Standard 7-16

Minimum Design Loads and Associated Criteria for Buildings and Other Structures

SUPPLEMENT 1

This document contains CHANGES to the above title, which is posted on the ASCE Library at <https://doi.org/10.1061/9780784414248>

FIGURE 21.2-1 Deterministic Lower Limit on MCE_R Response Spectrum

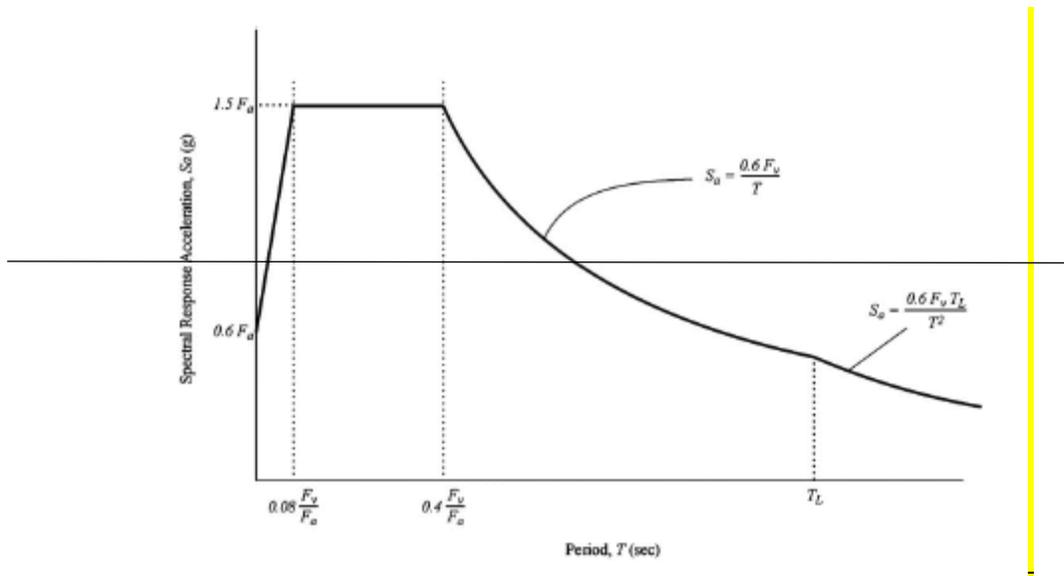
The deterministic spectral response acceleration at each period shall be calculated as an 84th-percentile 5% damped spectral response acceleration in the direction of maximum horizontal response computed at that period. The largest such acceleration calculated for the characteristic earthquakes on all known active faults within the region shall be used. If the largest spectral response acceleration of the resulting deterministic ground motion response spectrum is less than $1.5F_a$, then this response spectrum shall be scaled by a single factor such that the maximum response spectral acceleration equals $1.5F_a$. For Site Classes A, B, C and D, F_a shall be determined using Table 11.4.1, with the value of S_s taken as 1.5; for Site Class E, F_a shall be taken as 1.0. The ordinates of the deterministic ground motion response spectrum shall not be taken as lower than the corresponding ordinates of the response spectrum determined in accordance with Fig. 21.2-1. For the purposes of calculating the ordinates:

EXCEPTION: The deterministic ground motion response spectrum need not be calculated when the largest spectral response acceleration of the probabilistic ground motion response spectrum of 21.2.1 is less than $1.2F_a$.

- (i) for Site Classes A, B or C: F_a and F_v shall be determined using Tables 11.4-1 and 11.4-2, with the value of S_s taken as 1.5 and the value of S_l taken as 0.6;
- (ii) for Site Class D: F_a shall be taken as 1.0, and F_v shall be taken as 2.5; and
- (iii) for Site Classes E and F: F_a shall be taken as 1.0, and F_v shall be taken as 4.0.

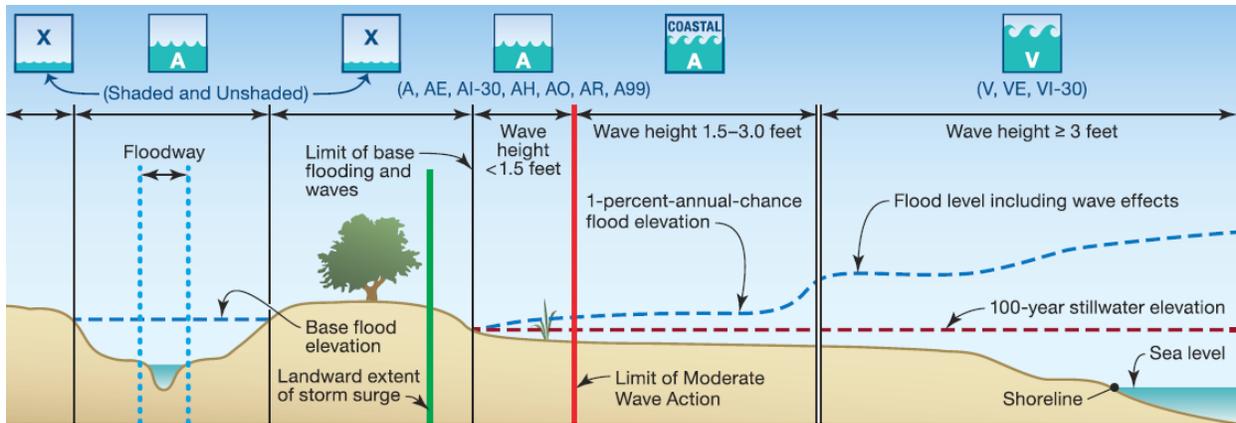
The variability in hydrostatic loads under flood conditions is small when compared with the variability in wave loads and hydrodynamic loads from overland flooding. For coastal flood situations where overland waves are small (in the Coastal A zone and A zone), application of the load factor of 2.0 to below-grade flood-induced (hydrostatic) loads is too conservative, and the 1.6 load factor specified for H loads in Section 2.3.1 is more appropriate. Fig. C2.3-1 illustrates the flood zones and load factors for F_a and H for flood water above grade and below grade.

FIGURE C6.6-3 Example EGLA with adjustment where an Inundation Depth Point is specified in the ASCE Tsunami Design Geodatabase

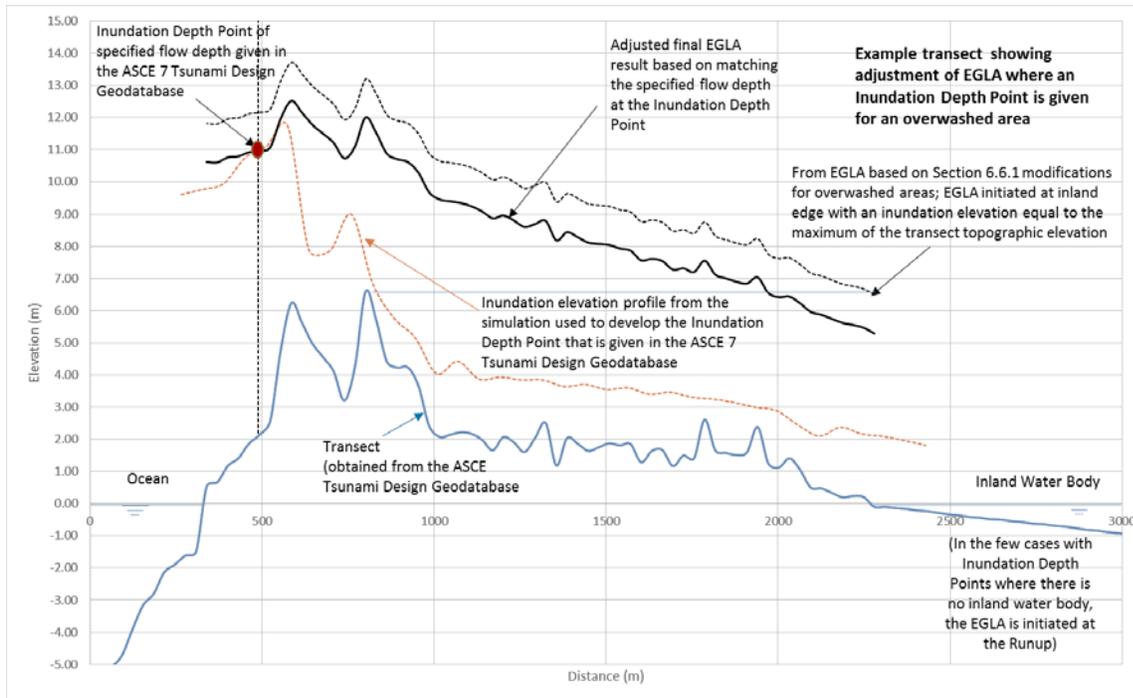
*Where Inundation Depth Points are provided for completely overwashed areas in the ASCE Tsunami Design Geodatabase, where the tsunami flows over an island or peninsula into a second water body, the horizontal distance of the inundation limit shall be taken to be the length of the overwashed land. There are two modifications of Section 6.6.1 given for this case relating to the initial conditions of nonzero depth and velocity at the inland edge of the overwashed area and the Froude number profile that follows a linear interpolation with distance across the overwashed land. To complete the analysis, the inundation elevation profiles are adjusted so that the computed inundation depths are at least the depths specified at the Inundation Depth Points. The adjusted inundation elevation profile should not be lower than the topographic elevation transect. An example is given in Fig. C6.6-3.

FIGURE C16.4-3 Expected Shear Strengths (in Terms of $F_v/F_{n,e}$) for Reinforced Concrete Shear Walls When Subjected to Various Levels of Flexural Ductility

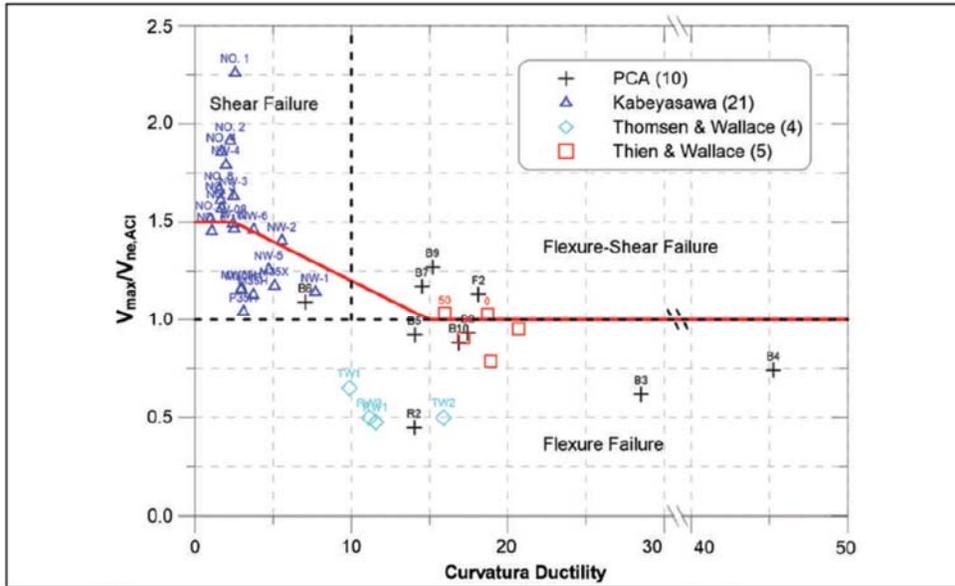
~~Where an industry standard does not define expected strength~~ expected (or mean) strength, F_e , is computed as follows. First, a standard strength-prediction equation is used from a material standard, using a strength reduction factor, ϕ , of 1.0; the expected material properties are also used in place of nominal material properties. Typically, the nominal resistance values specified in the materials standards incorporate a moderate level of conservatism, on the order of 10% to 15% associated with material strength that exceeds specified strength, and also intentional conservatism associated with fitting design equations to research data. In some cases, this estimate of strength ($F_{n,e}$) may still be conservative in comparison with the mean expected strength shown by experimental tests (F_e) caused by inherent conservatism in the strength equations adopted by the materials standards can be substantially larger than this. If such conservatism exists, the $F_{n,e}$ value of R_n , which is a calculated capacity that is most closely represented by $V_{ne,ACI}$ in Fig. C16.4-3, may be multiplied by a “component reserve strength factor” bias factor, B , greater than 1.0, to account for empirical capacity (R_{ne}). ~~to produce the estimate of the mean expected strength (F_e). This process is illustrated in Fig. C16.4-3, which shows the $F_e/F_{n,e}$ R_{ne}/R_n ratios for the shear strengths from test data of reinforced concrete shear walls (Wallace et al. 2013). This figure shows that the ratio of $F_e/F_{n,e}$ R_{ne}/R_n depends on the flexural ductility of the shear wall, demonstrating that $F_e/B = 1.0$ $F_{n,e}$ is appropriate for the shear strength in the zone of high flexural damage and $F_e = 1.5 F_{n,e}$ a value of $B = 1.5$ is appropriate in zones with no flexural damage.~~
